Request for Class II Permissive Change(C2PC)

FCC ID: VG8XM136AYYW-PV5

Date: 2023-12-05

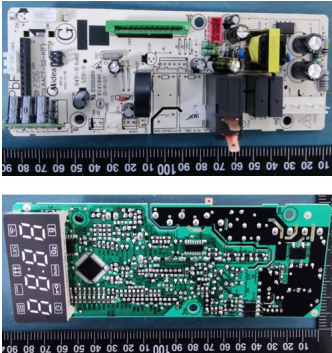
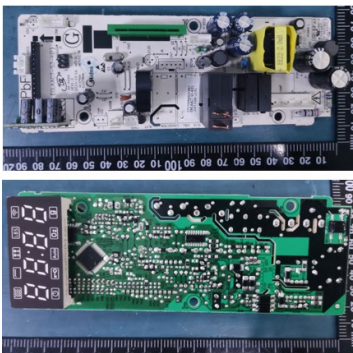
No.:	Original	New	Difference(s)
1			Keypad: Updated front keypad to accommodate child lock function (Child resistant oven door function)
2			Mother board: Modified the peripheral circuit (non-RF circuit) and some individual components and PCB layout. The magnetron and other circuit are exactly same as before
3	N/A		The new one adds a solenoid valve locking mechanism, the original is not.
